Design Review Subcommittee (DRSC)

Meeting Date: September 15, 2021

SUBJECT: **Cultural Heritage Permit 21-001/Minor Exception Permit 21-173, Fox Duplex**, a request to consider the construction of a two-story duplex building on a vacant lot, adjacent to property in the City's List of Designated Historic Resources.

SITE PLAN
CHP 21-001
PROJECT: DUPLEX
214 W. MARIPOSA
SAN CLEMENTE, CA.
92672
OWNER: 505 ARDILLA LLC
238 AVENIDA VICTORIA
SAN CLEMENTE, CA. 92672
TAYLOR FOX: (949) 607-8880
TAYLORFOX@GMAIL.COM
A1

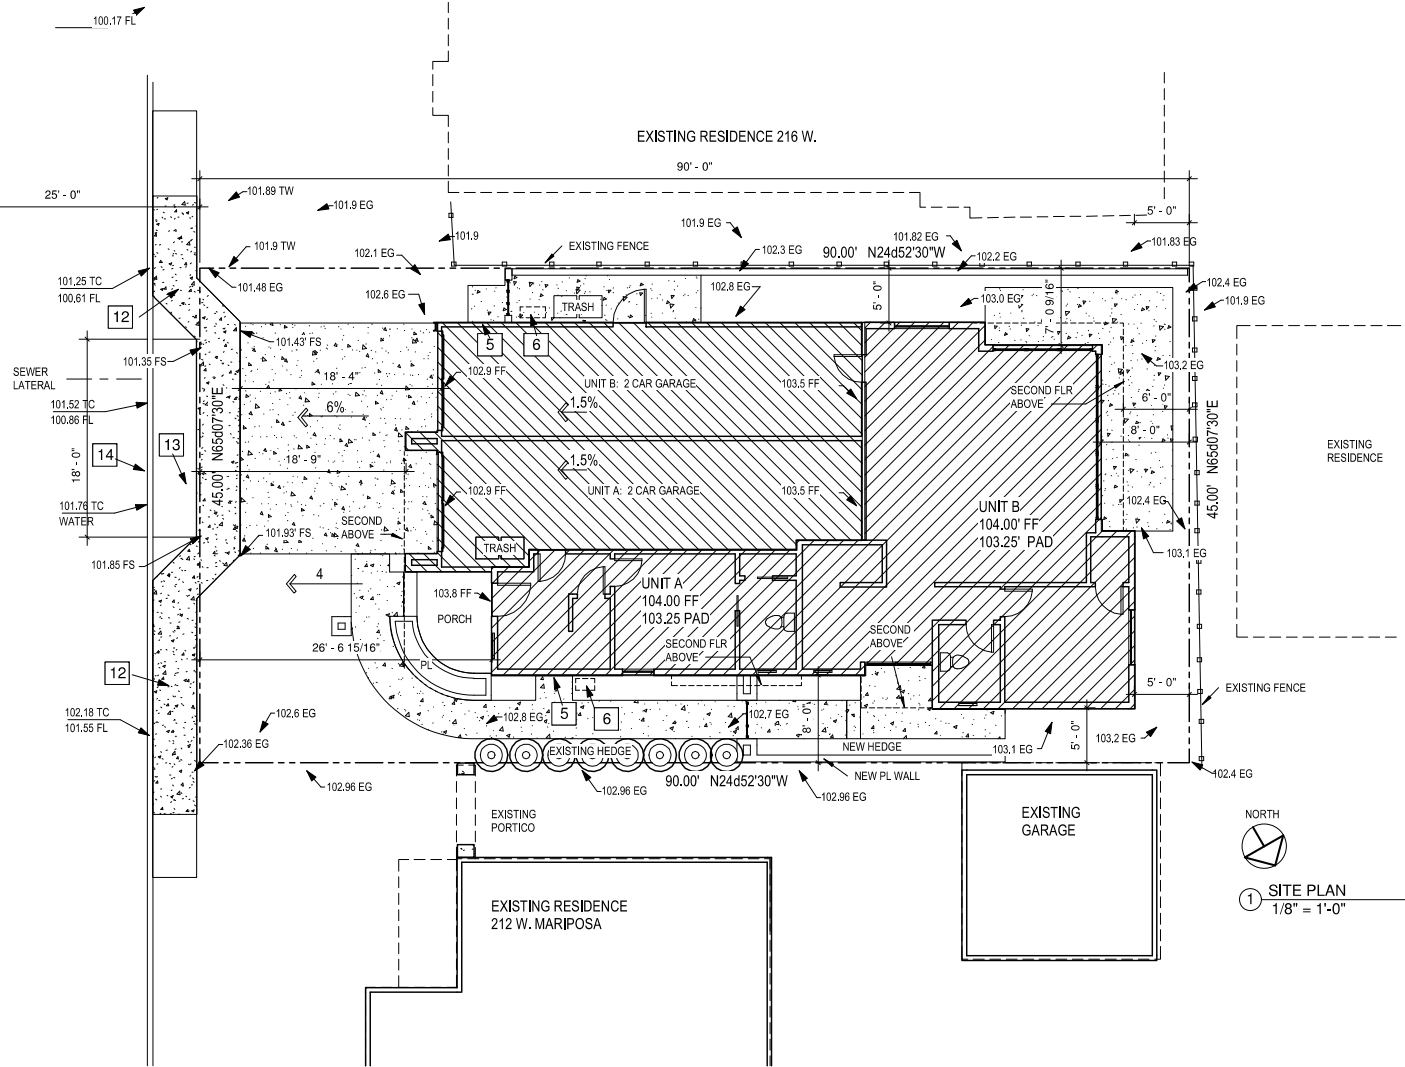
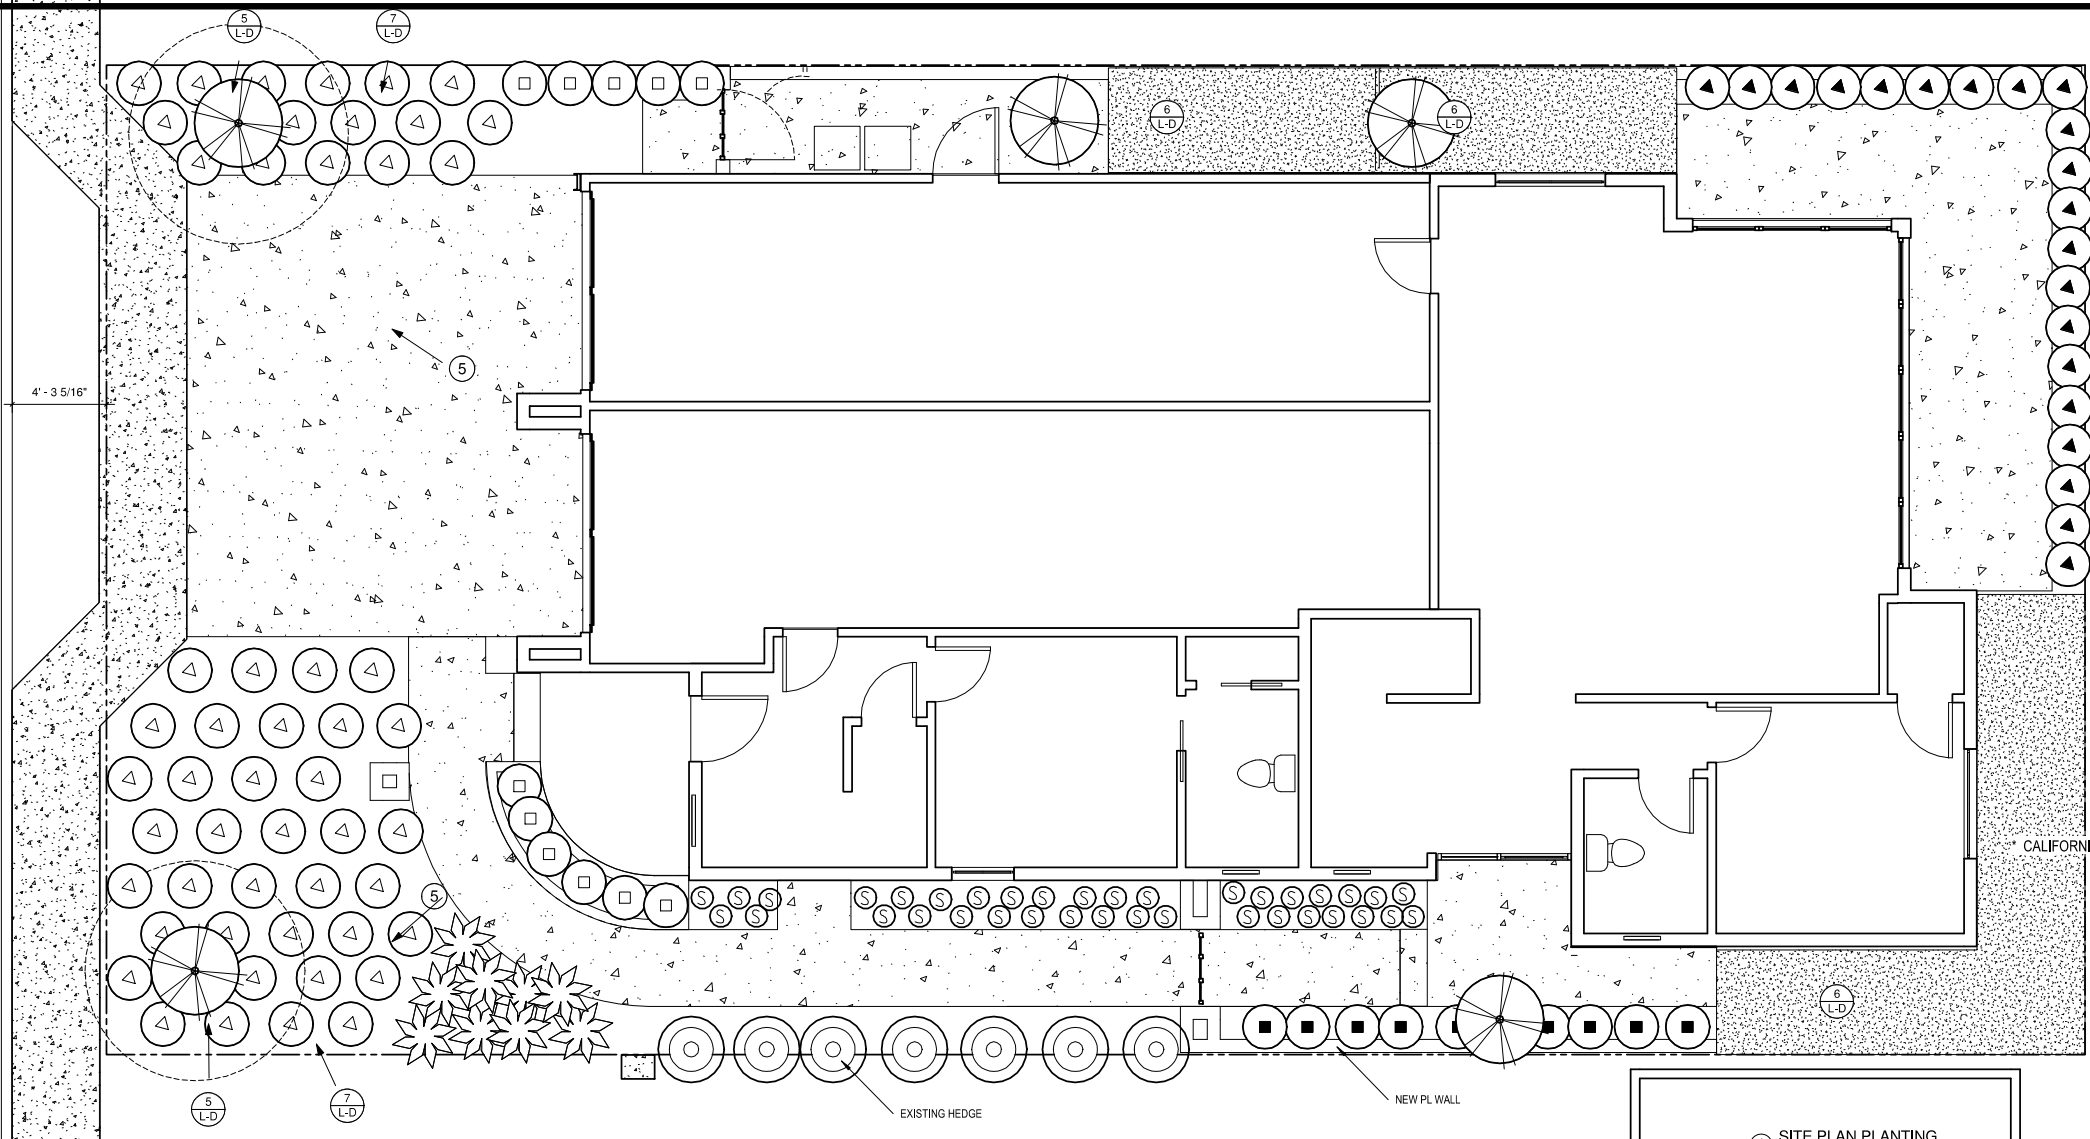
Staff Recommendation	Applicant's Response
Maintain the existing hedge between the project site and historic property, or if the hedge must be removed, replace with a similar hedge or vertical landscaping	The adjacent existing hedge can remain in place for up to 20 feet beyond the existing portico along the property line (as seen on the site plan sheet A1). We feel a privacy

1. Maintain the existing hedge between the project site and historic property, or if the hedge must be removed, replace with a similar hedge or vertical landscaping.

1. The adjacent existing hedge can remain in place for up to 20 feet beyond the existing portico along the property line. (as seen on the site plan sheet A1) . We feel a privacy wall matching the Spanish revival style is necessary at the entrance to Unit B.

3 EAST VIEW
1/4" = 1'-0"

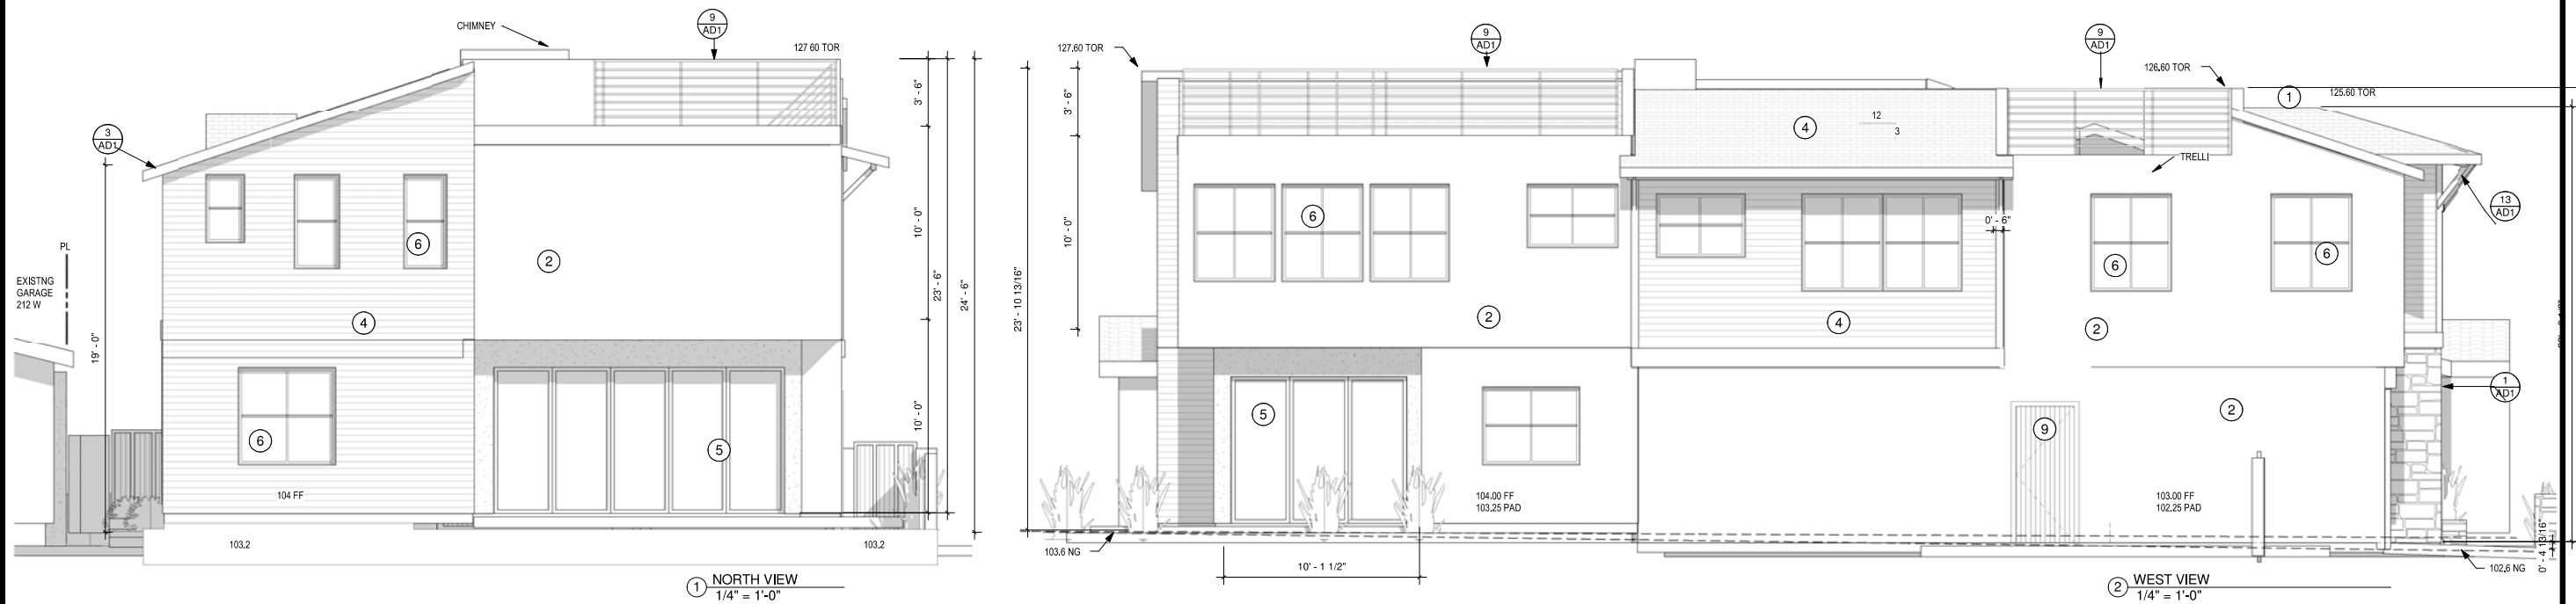
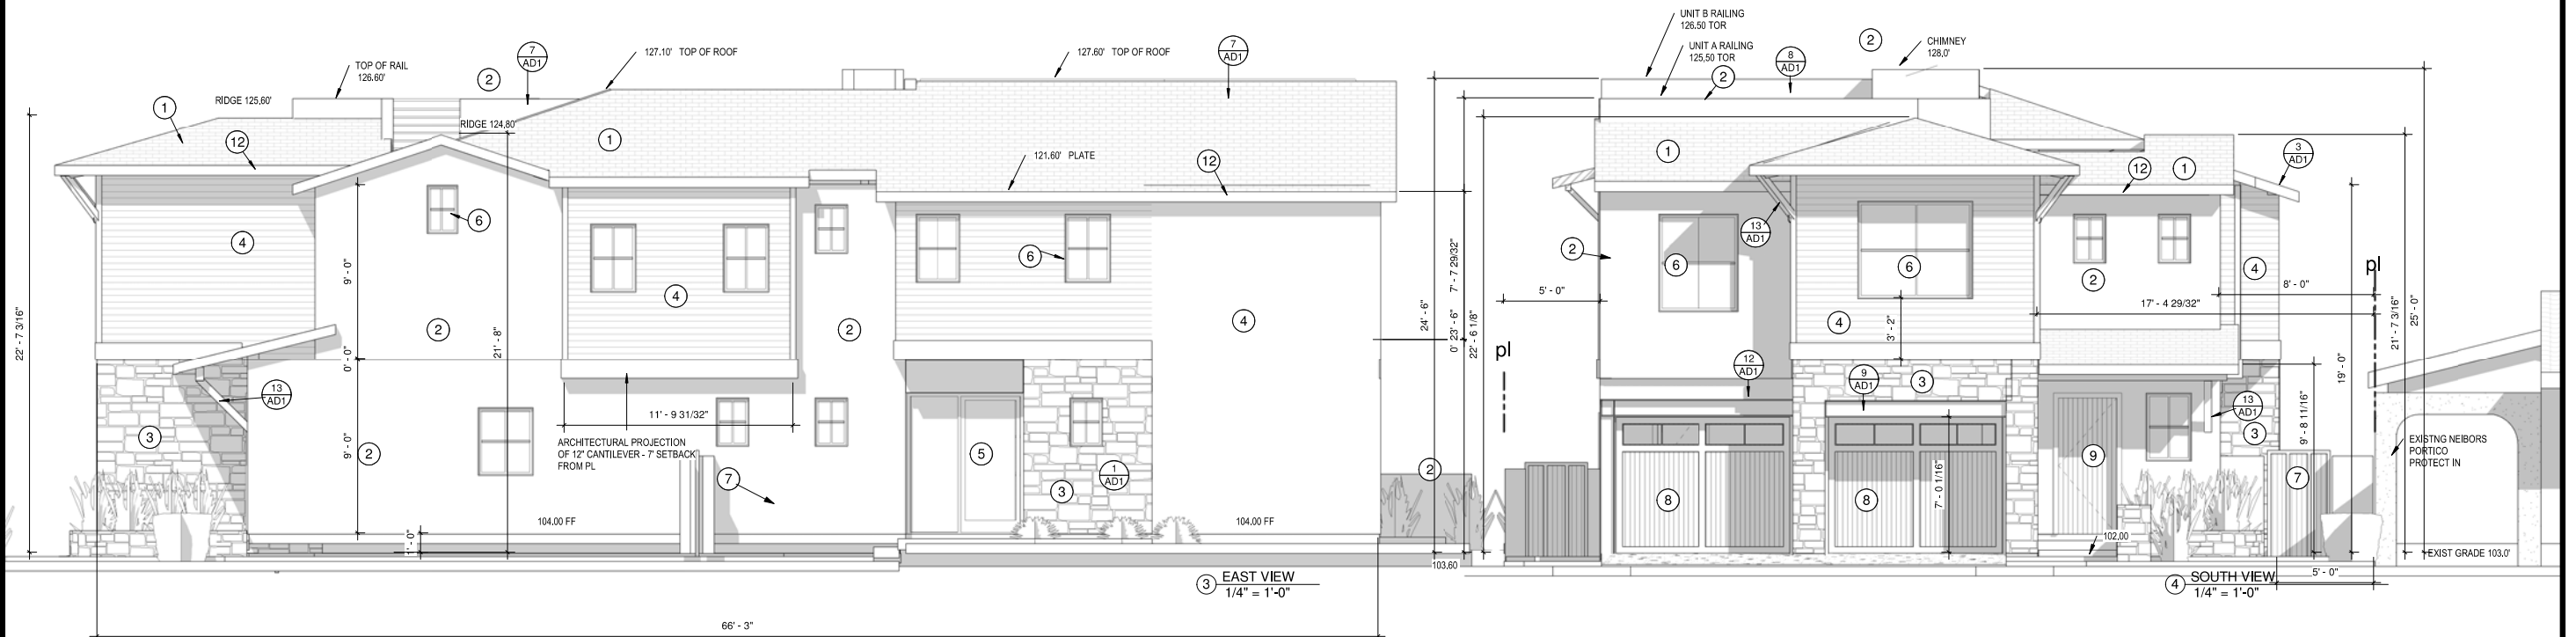
Remove the side-yard encroachment on the east elevation.	The request for the 6" side yard encroachments have been removed.

2. Reduce the size of the window for bedroom #3 on the second floor, to improve privacy of the historic rear yard.
3. Reduce building mass to further show sensitivity to the historic resource and to improve light and sun exposure of the historic resource.

8. Address comments provided by the City's Landscape Consultant.
9. Remove the side yard encroachment on the east elevation.

The east side roof plane has been simplified and the use of higher hip roof elements has been eliminated. The cantilever on the east side has been reduced to 12" wide x 11' -9" long. Bedroom windows along the east side shall be two 28X60 windows on the side of the room in lieu of the larger center window this will provide privacy to the adjacent site back yard.

2. Bedroom windows along the east side shall be two 28x60 windows on the side of the bed in lieu of the larger center window this will provide privacy in that a nightstand will be in front of the window and will provide the required light and ventilation without providing a large viewable center window.

8. The landscaping material will be greater than 60% drought tolerant native material.
9. The request for the 6" side yard encroachments have been removed.
